Mitigation for Uplands

For consideration at the resumed without prejudice Conditions Session

We, John and Annie Owen, of Uplands in Bentley, are writing - yet again - about the almost total lack of mitigation offered us by those planning a solar park in the middle of our village. We also wish to consider what form any future mitigation offer might take.

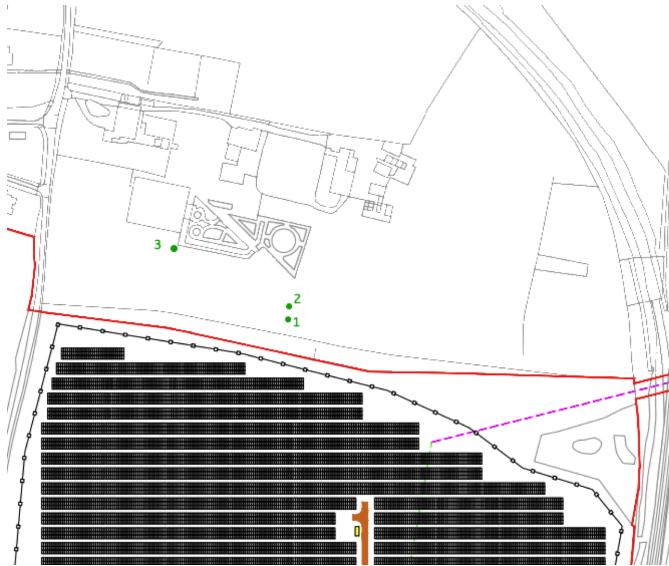
Our track is missing from both of these site plans. In the left-hand plan, the line of fluffy green vegetation between the eastern site and Uplands gives the impression of screening. The two photos we have provided show how misleading that is. Our track, which we use on a daily basis, is between the solar park site and our line of trees (first photo). Our trees are low-lying (our land dips down towards the boundary) and

deciduous, therefore providing no screening in the leafless months (second photo). The poplars behind them - remnants of the time when Uplands was a fruit farm and characteristic of fruit farms across Suffolk - are sparse and very tall, thus providing no screening all year round.
